Access Compliance Report

Public Rights-of-Way

(Curb Ramps)

Intersection ID: 12151	Main Street: W_MOREHEAD_ST	Cross Street: MILLERTON_AV	Location: SW
ADA ID: A7E1CAEE689B	Ramp Type: PerpDiag	Initial Pass/Fail: Fail	Overall Compliance: No
Severity Score: 21.25			
Codes/Mitigation Info/Possible Solution		Field Measurements/Component Compliance

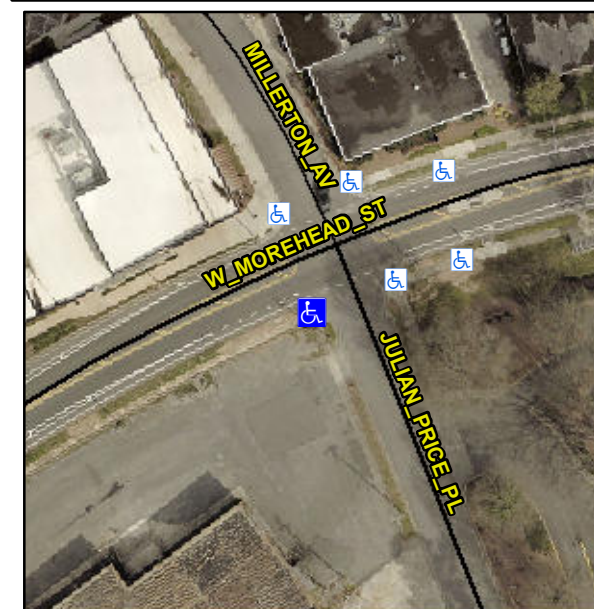
Not Found, R304.5.1, R304.2.2

Compliance	Description	Data	Compliance	Description	Data
N/A	Ramp Length (in)	54.0	No	Ramp Slope (%)	9.7
No	Ramp Width (in)	43.5	Yes	Ramp XSlope (%)	0.6
N/A	Flare Type LT	N/A	N/A	Flare Type RT	N/A
N/A	Flare Slope LT (%)	N/A	N/A	Flare Slope RT (%)	N/A
N/A	Flare Traversable LT?	N/A	N/A	Flare Traversable RT?	N/A
N/A	Landing Length (in)	N/A	N/A	DWS Provided?	N/A
N/A	Landing Width (in)	N/A	N/A	DWS Contrast?	N/A
N/A	Landing Slope (%)	N/A	N/A	DWS Length (in)	N/A
N/A	Landing X Slope (%)	N/A	N/A	DWS Full Width?	N/A
N/A	Landing Curb? (Y/N)	N/A	N/A	DWS Offset (in)	N/A
N/A	Shared Landing?	N/A			
N/A	Gutter Ponding?	N/A	N/A	Gutter Slope (%)	N/A
N/A	Gutter Lip Ht (in)	N/A	N/A	Gutter X Slope (%)	N/A
N/A	Painted X Walk1?	No	N/A	Painted X Walk2?	No
	X Walk 1 Direction	To E		X Walk 2 Direction	To N
N/A	X Walk 1 Width (in)	N/A	N/A	X Walk 2 Width (in)	N/A
	X Walk 1 Slope (%)	0.4		X Walk 2 Slope (%)	5.3
	X Walk 1 X Slope (%)	1.9		X Walk 2 X Slope (%)	0.3

Remove & Replace Curb Ramp With Two New Directional Ramps or Equivalent.
